**From:** [REDACTED]  
**To:** [REDACTED]  
**CC:** [REDACTED]  
**Sent:** 2/23/2021 3:00:52 PM  
**Subject:** RE: O8W-PM 35217268, 35224712, 35224713 - Bucks Creek 1101 Phase 1,2&3 - Pre-Engineering Meeting

# Bucks Creek 1101- PM# 35217268 Overview Map

PM 35217268 (Phase 1)

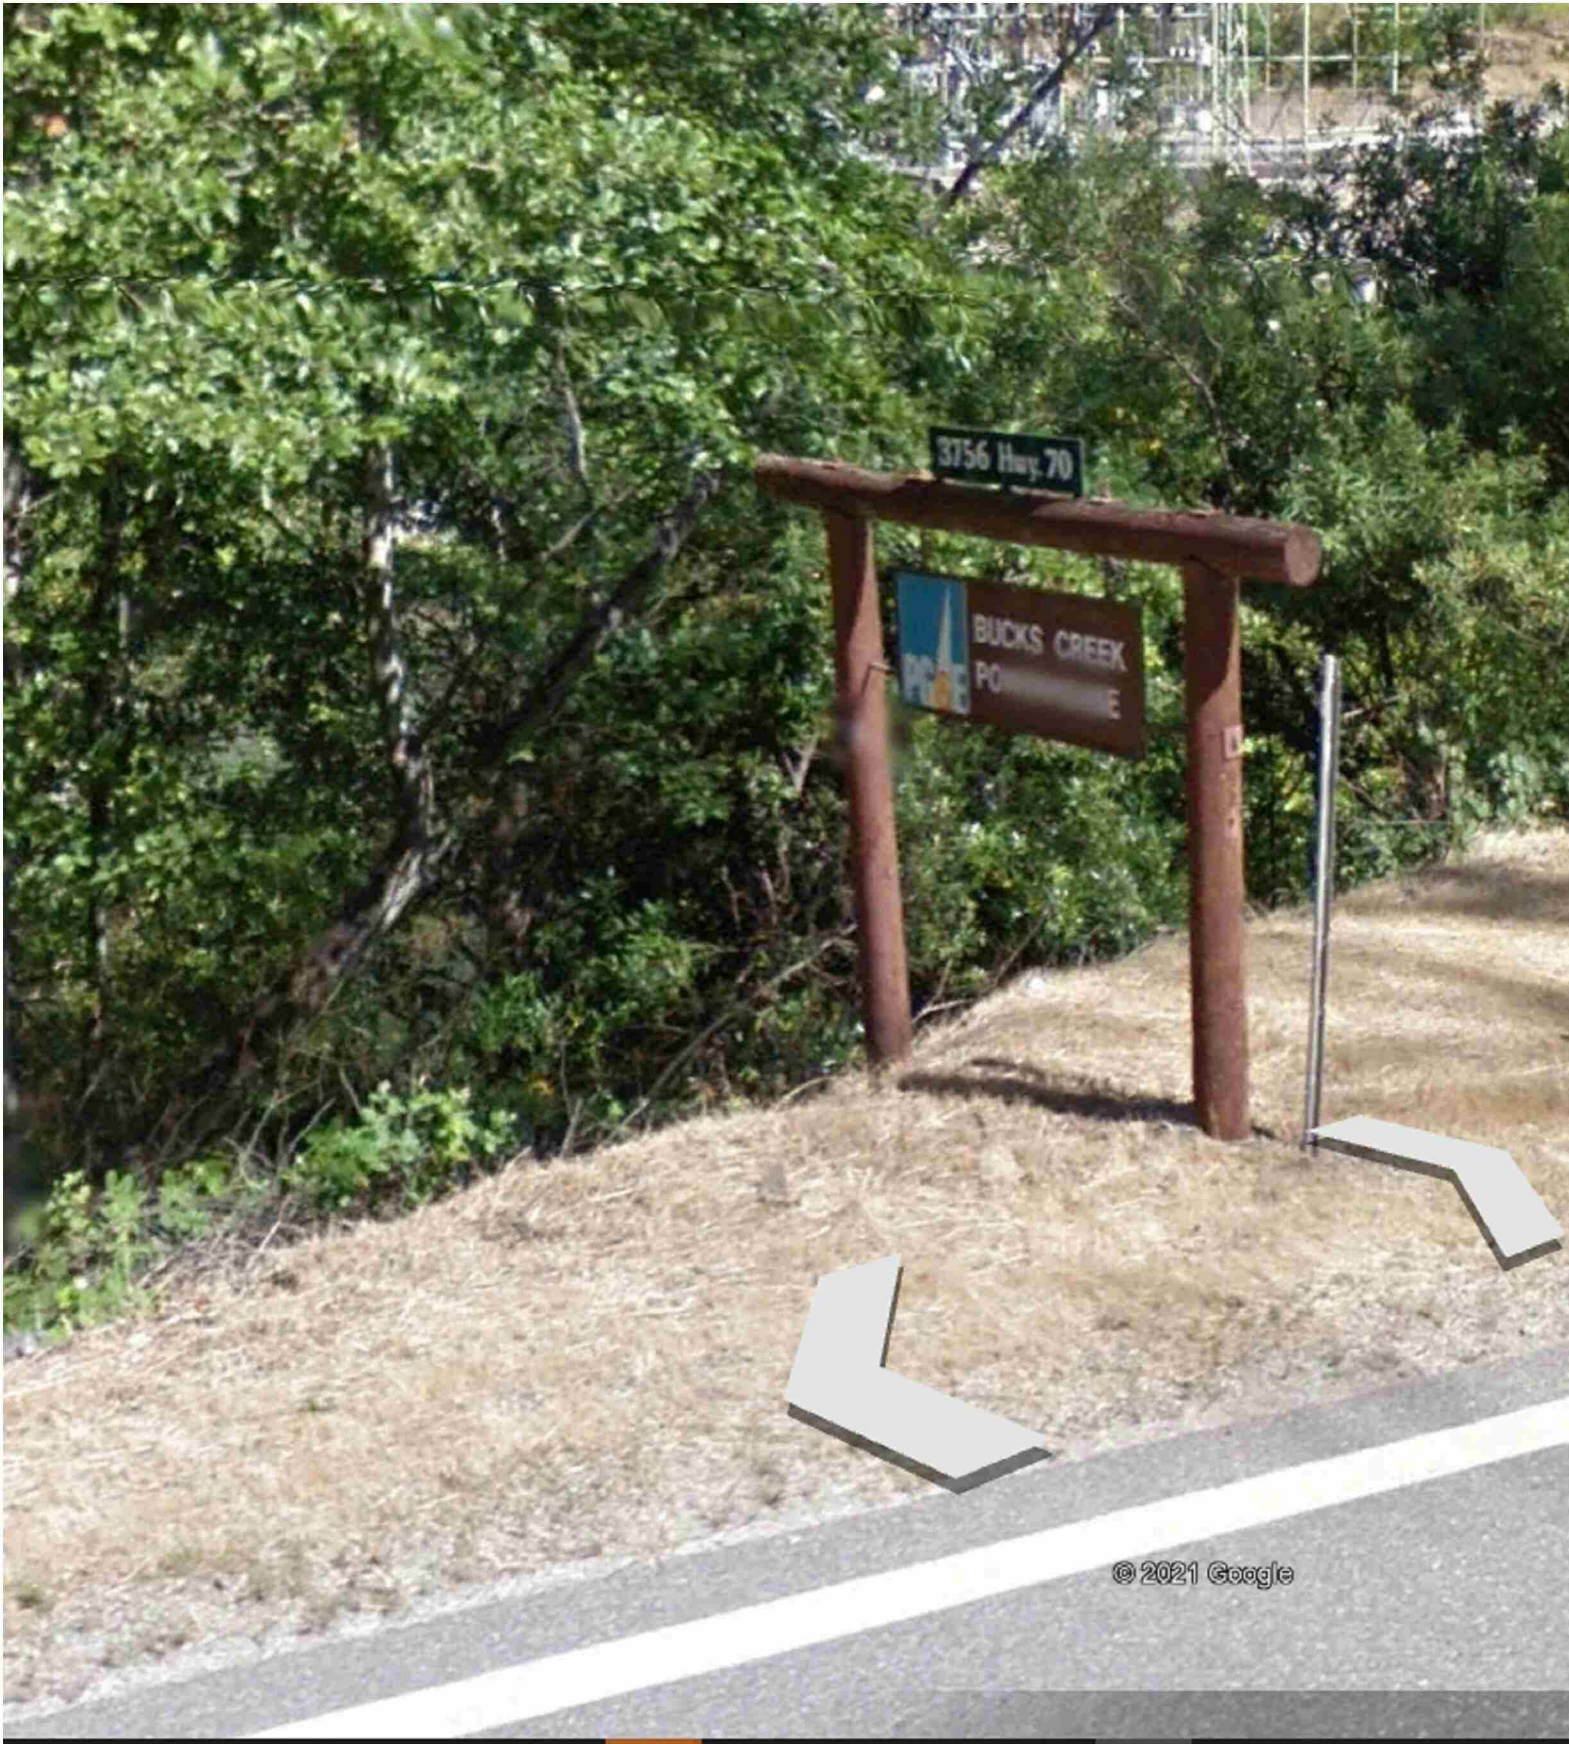
Attached are the 'base-map' limits in a kmz. file. As you will see, we need our base-map to go about ~100' into the tunnel at the south end (see pedestal in picture below....please begin about ~50 beyond this point which is about ~100' beyond the Cresta Dam).

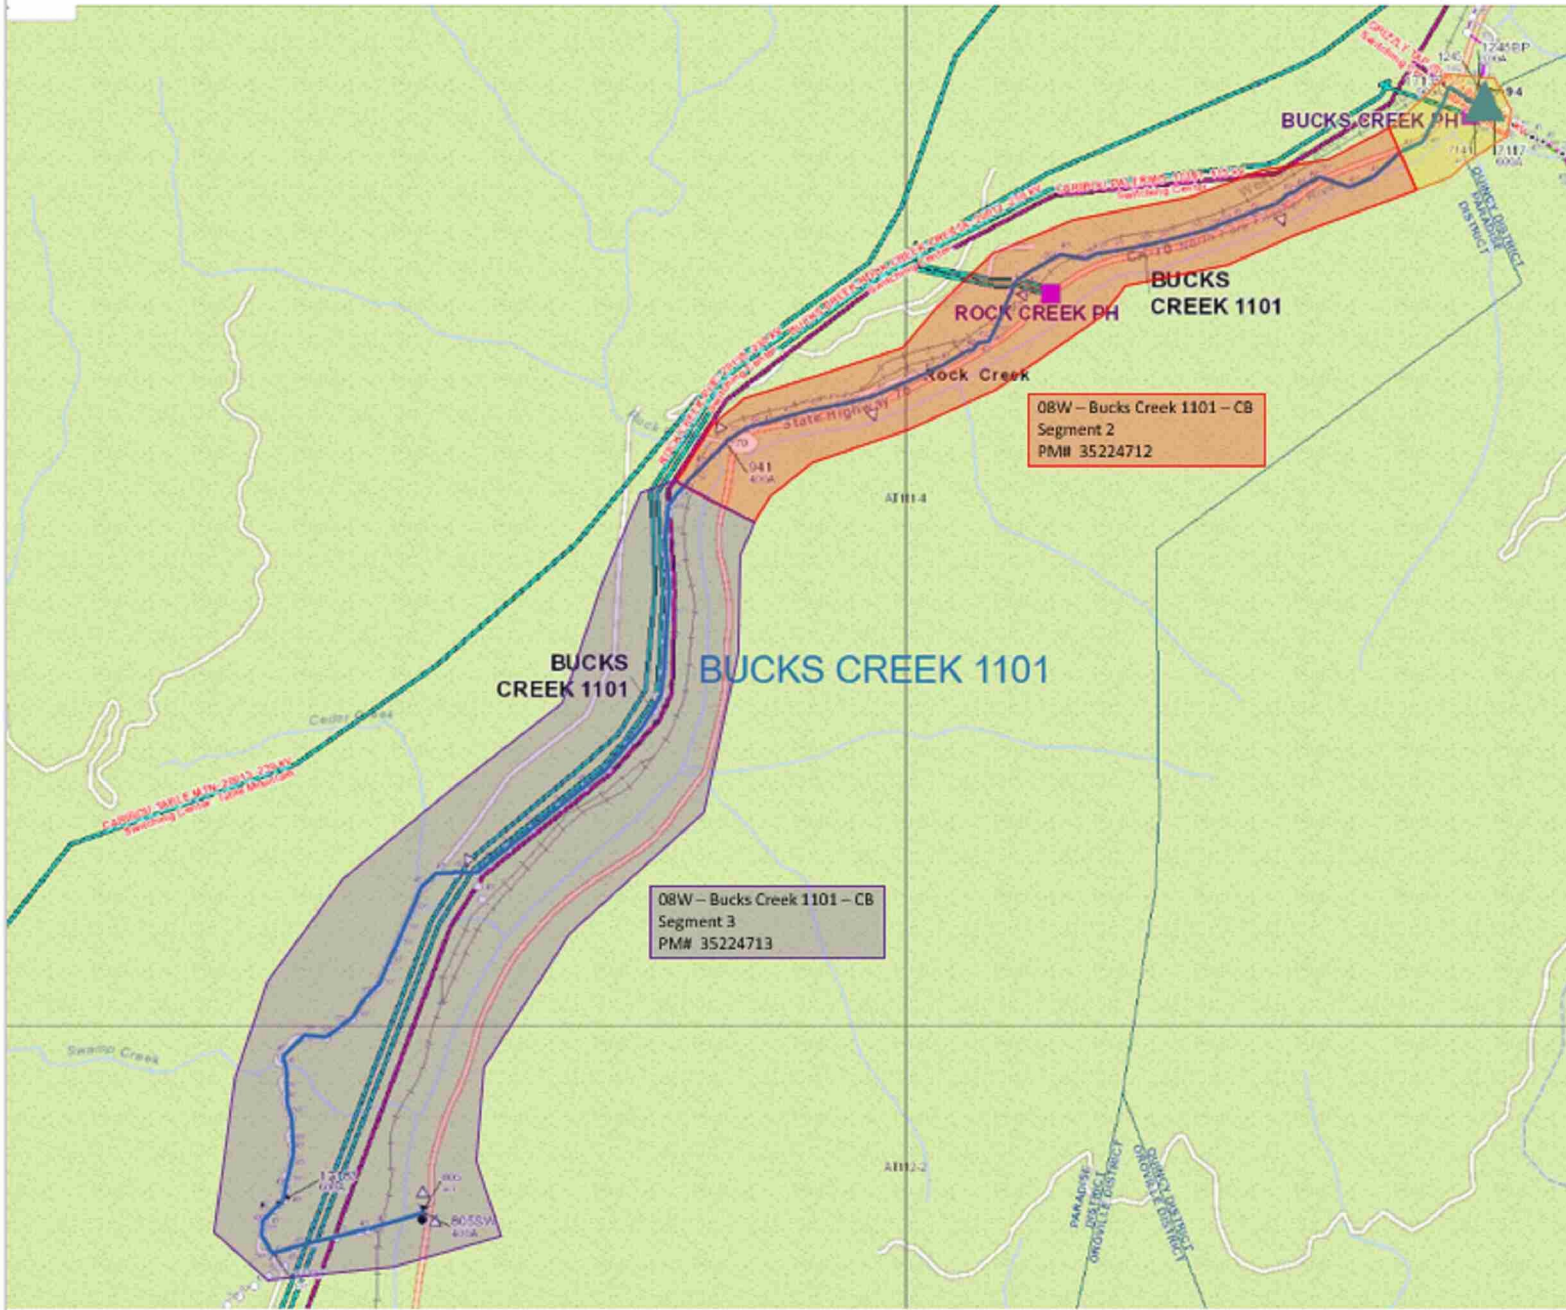
For Bucks Creek there is quite a bit of work surrounding Hwy 70 and we will need a Land Department Base Maps prepared for all 3 Orders. This will delay the EOD dates until these can be developed and provided to the Vendor... We will also need answers to the questions outlined by [REDACTED] below...
